Docket Item # 14 & 15
BAR CASE #2015-0194 & 0195

BAR Meeting
September 16, 2015

ISSUE: Permit to Demolish/Capsulate and Certificate of Appropriateness (alterations & addition)

LOCATION: 821 S Royal Street

Figure 1: January 2014 BAR approval – rear elevation

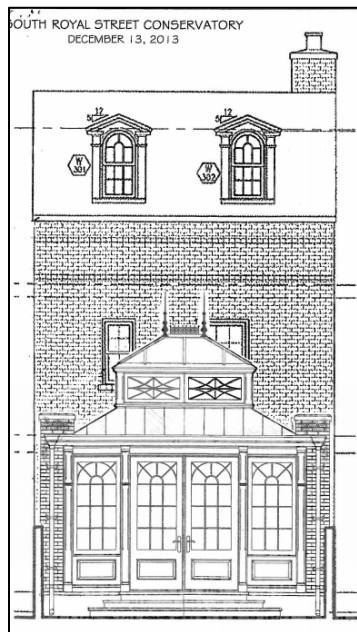
The change in proposed rear roof slope will add approximately 3' - 3.5' to the height of the west elevation, which will have painted wood panels and inset gable roof dormers. The dormers match the Board's previously approved dormers.

As with the previously proposed rear conservatory, Staff recommends re-approval of the one-story addition. The *Design Guidelines* encourage “designs that are respectful of the existing structure and which seek to be background statements or which echo the design elements of the existing structure.” The one-story rear addition is well designed and appropriately scaled, and will have less of a visual impact than the two-story rear addition approved in 2002. The proposed cupola is well proportioned and Staff does not believe that the additional depth of the conservatory will have an adverse effect on neighboring properties. Because there is no rear alley, public views will be limited to the break between houses on South Pitt Street.

Figure 4: Proposed front facade

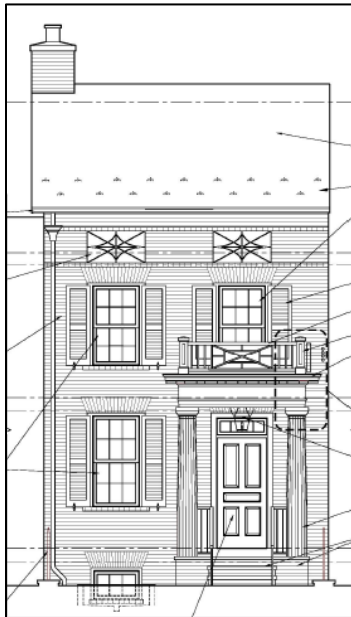
On the front façade, the improvements are also consistent with the Board's prior approval, with the exception of the inset panels, which will now have more simplified grill work. In addition, the light fixtures previously flanking the entrance will be replaced with a single copper-finished hanging light fixture.

The front portico is similarly well designed and not an uncommon feature on Yates Garden townhouses. The alterations will improve the current appearance of the townhouse, which has been unoccupied for years.
